FIGURE 1. INFILTRATION AND RUNOFF DEPTHS FOR 1,000-ACRE LIGHT COMMERCIAL AREA FOR WY 2003

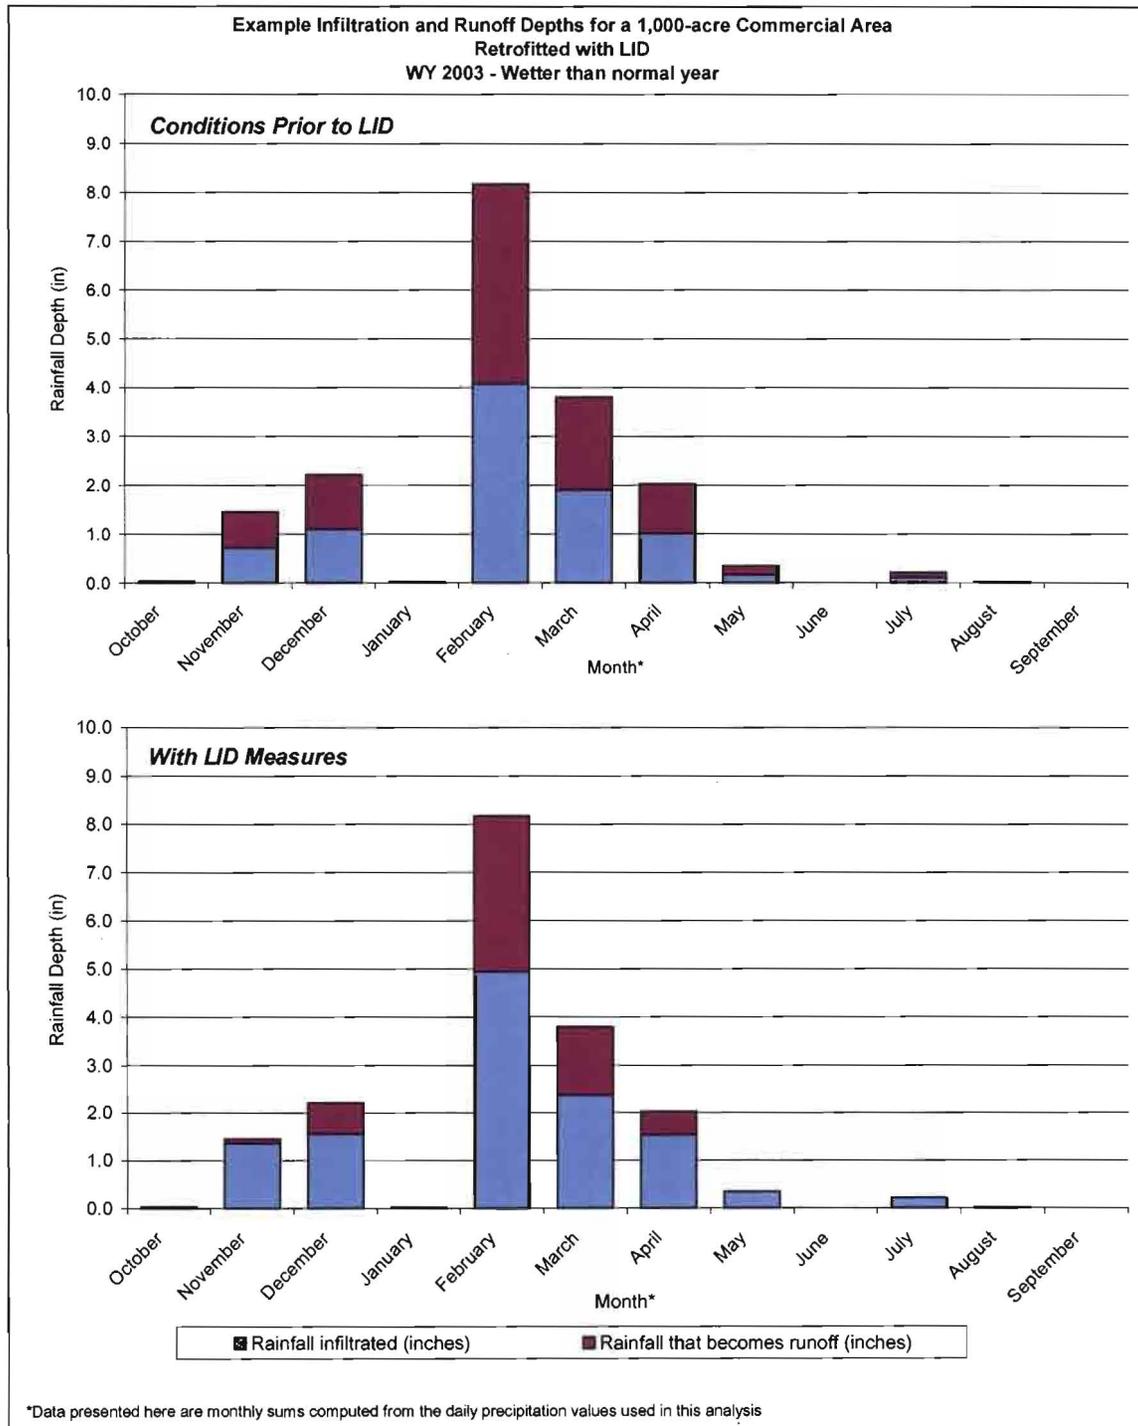
A typical estimate of the runoff coefficient¹ for a commercial site is 0.5, meaning 50% of rainfall will infiltrate or evaporate, and 50% will run off as surface water (Caltrans, 2008). Prior to LID retrofit, the quantity of surface water runoff from this area in WY 2003 was 760 acre-feet (50% of the 18.3 inches, applied to 1,000 acres). With LID in place, the first 0.8 inches of rainfall from each event is assumed to be captured and infiltrated on-site. The remainder of the rainfall is assumed to infiltrate and run off following the same runoff coefficient of 0.5. In WY 2003, about 6.5 inches of rainfall would be captured and infiltrated by LID measures; of the remaining 11.8 inches of rainfall, 5.9 would also infiltrate, and 5.9 inches would become surface runoff. This equates to an annual surface water runoff volume of 490 acre-feet. The result of LID is a 270 acre-feet net reduction in surface water runoff downstream of the LID site. For comparison, this amount equates to 2% of the flow at the Murrieta Creek gage for WY2003. The rainfall, infiltration, and runoff volumes are given in Table 1. Figure 1 also shows the infiltration and runoff depths before and after implementation of LID measures.

FIGURE 2. INFILTRATION AND RUNOFF DEPTHS FOR 1,000-ACRE COMMERCIAL AREA FOR WY 2006

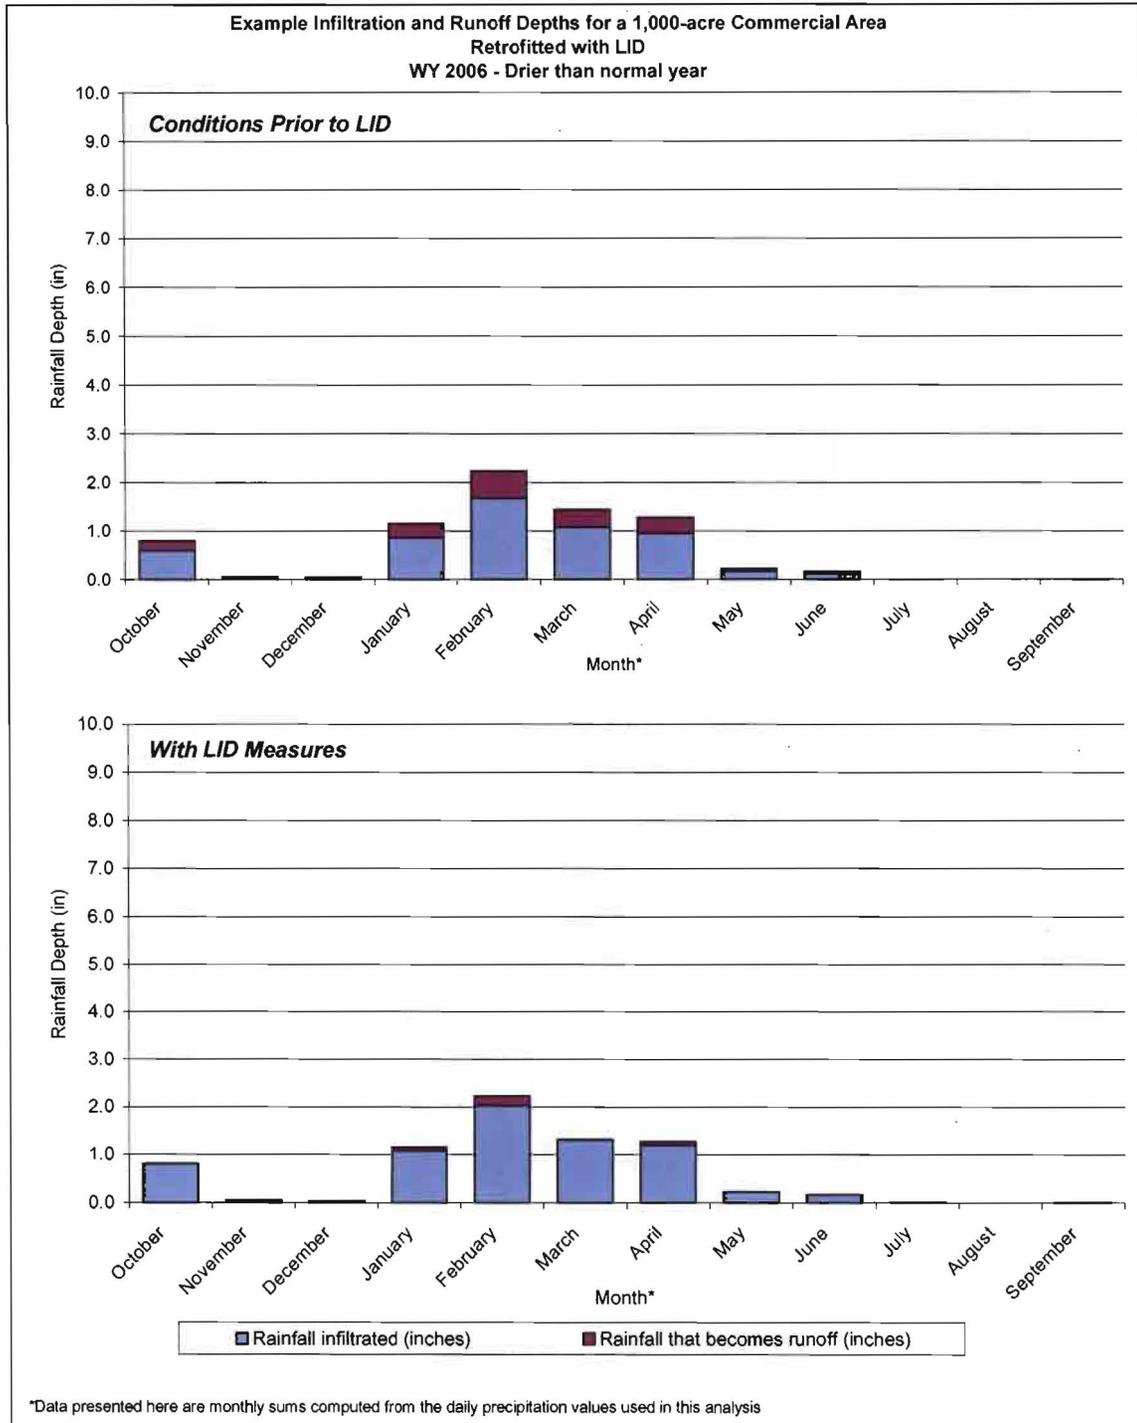
If the same assumptions are applied to the 1,000-acre commercial area using WY 2006 rainfall, 5.8 inches of the total 7.4 inches of rainfall would be captured by LID measures. However, in this case, the runoff coefficient is assumed to be 0.25, in order to account for the dry conditions. Dry antecedent conditions mean a higher percentage of rainfall would infiltrate. The pre-LID runoff quantity is 155 acre-feet, while the post-LID runoff quantity is 33 AF, resulting in a net reduction of 120 acre-feet of surface water flows immediately downstream of the site. Compared to the total flow at the Murrieta stream gage, the additional water infiltrated on-site amounts to 2% of the total flow at the gage for WY 2006. The rainfall, infiltration, and runoff volumes are given in Table 1. Figure 2 also shows the infiltration and runoff depths

before and after implementation of LID measures. The net reduction in surface water flows could be higher if larger areas of existing development are retrofitted with LID or if the sites have higher runoff coefficients.

FIGURE 3. NON-AUGMENTED FLOW AT THE SANTA MARGARITA RIVER GORGE

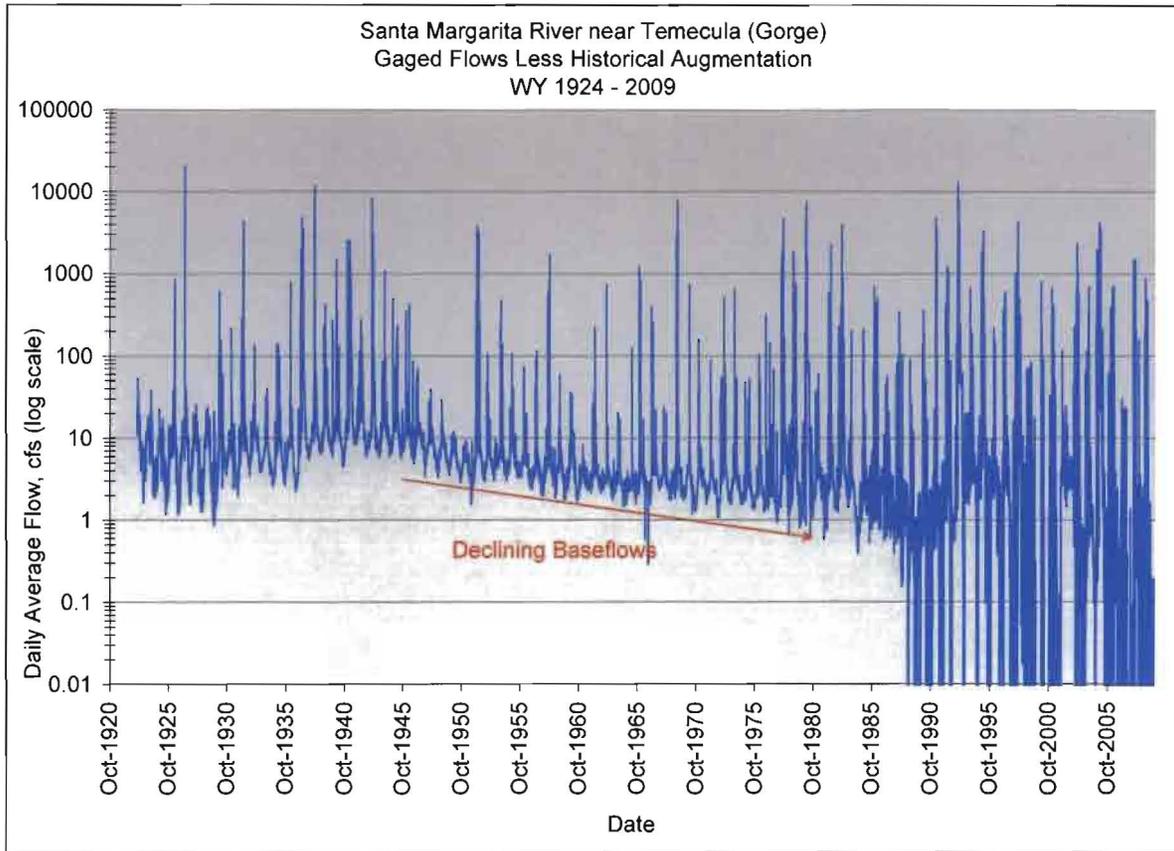
The policy of promoting on-site infiltration in the upper Santa Margarita River watershed will reduce surface water flows to Camp Pendleton. In the 1950s and 1960s, groundwater pumping in the upper Santa Margarita basin led to a disconnection between the upper basin and the lower basin (the limit between the two is the Temecula Gorge). This is demonstrated by Figure 3, which shows the decline in baseflows in the River at the Gorge. Because of this disconnection, increasing infiltration in the upper groundwater basin will increase groundwater storage in the upper basin, but none of this water will be conveyed to the lower watershed. Instead, additional water infiltrated on-site by the proposed Order will be retained for use by groundwater pumpers upstream of Camp Pendleton. The Base's ability to exercise its water right to use water from the Santa Margarita River will likely be impacted from diminished surface water flows resulting from the proposed Order.

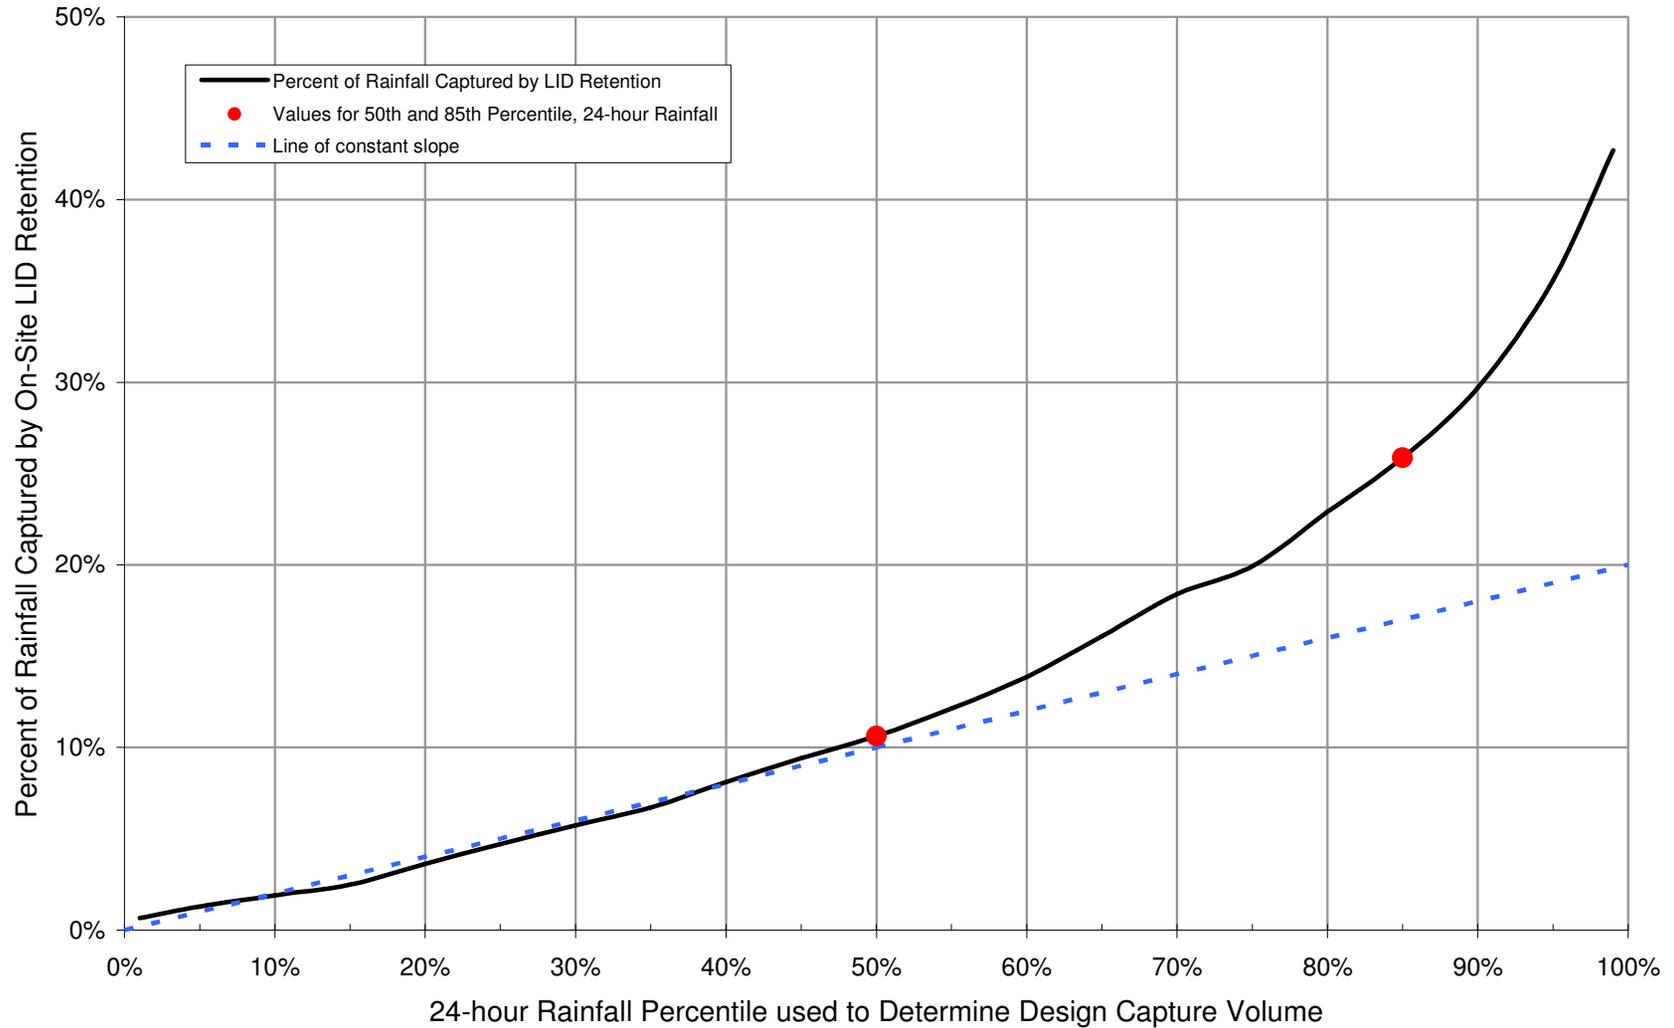
- A hypothetical, daily model of LID capture was created to simulate long-term retention by LID at a single site.
- The site is assumed to have a runoff coefficient of 0.50 for every storm, regardless of antecedent conditions. This is a simplification which allows us to make a relative comparison between design storm percentiles.
- The table below presents the percent of rainfall that is retained by LID for different percentiles of the 24-hour storm
- The figure shows the data from the table in graphical format
- The slope of the line begins to increase at about the 50th percentile storm

Percent of Rainfall Captured at a Single Site by LID Retention
Based on Hypothetical, Long-Term Daily Model using Rainfall from Wildomar Gage,
WY 1925-2008
Site Runoff Coefficient of 50%

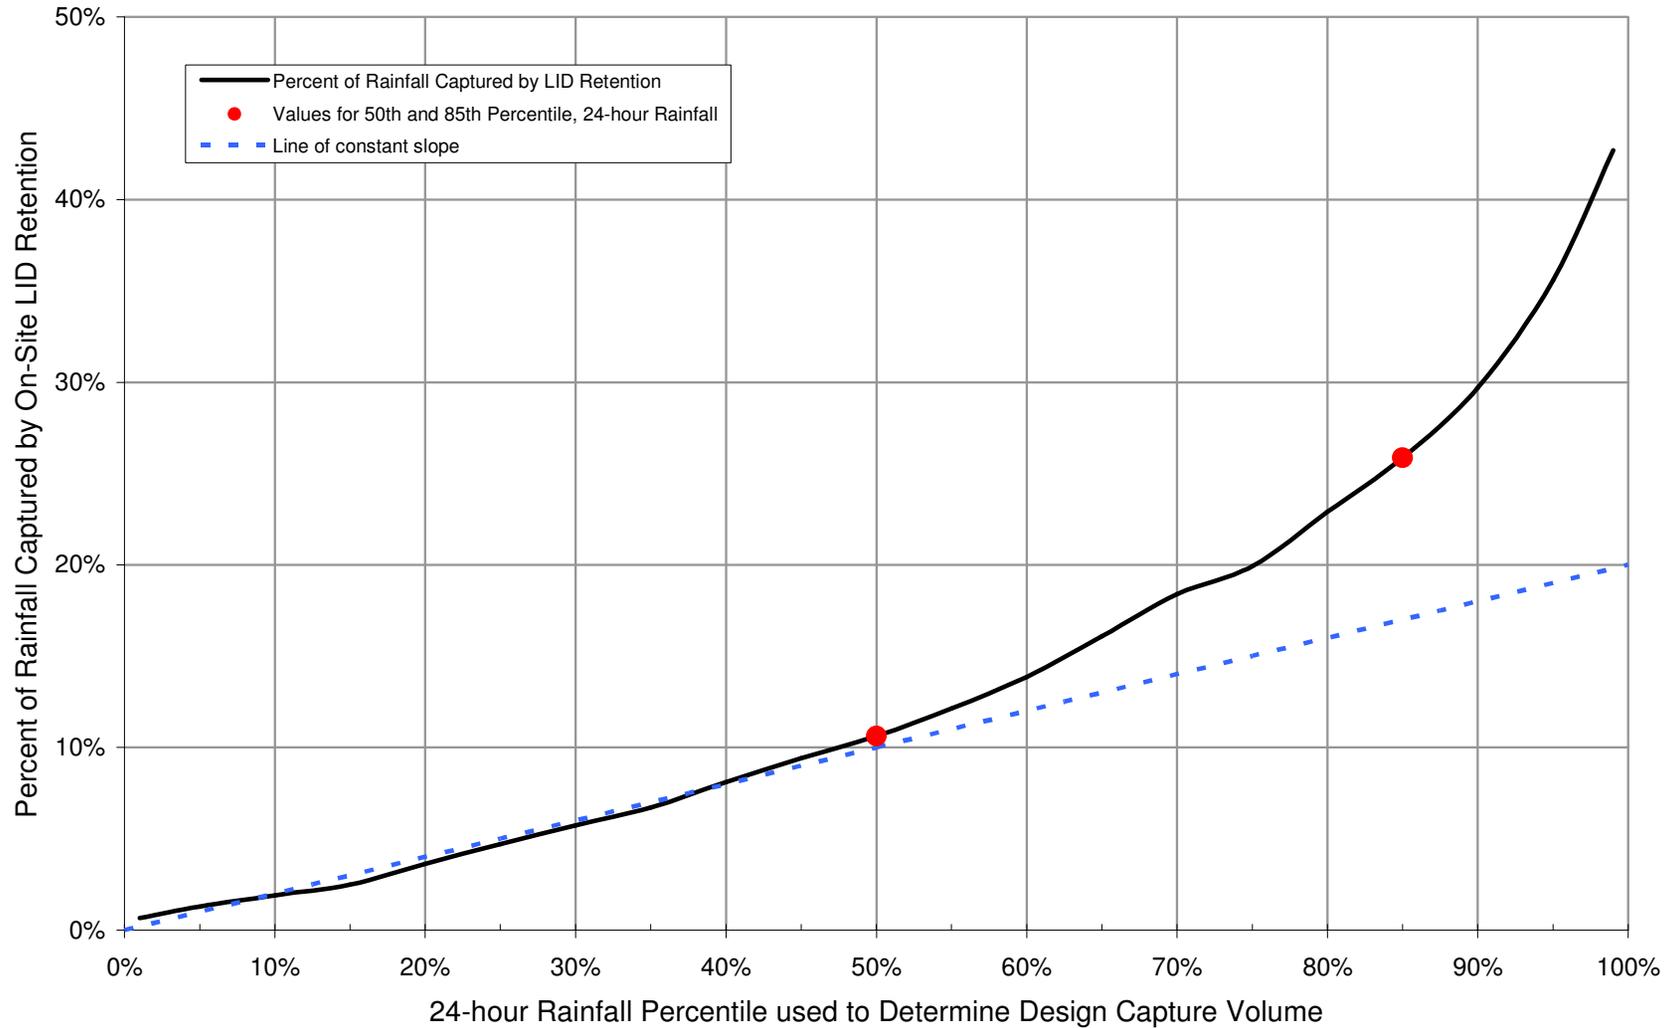
- A hypothetical, daily model of LID capture was created to simulate long-term retention by LID at a single site.
- The site is assumed to have a runoff coefficient of 0.50 for every storm, regardless of antecedent conditions. This is a simplification which allows us to make a relative comparison between design storm percentiles.
- The table below presents the percent of rainfall that is retained by LID for different percentiles of the 24-hour storm
- The figure shows the data from the table in graphical format
- The slope of the line begins to increase at about the 50th percentile storm
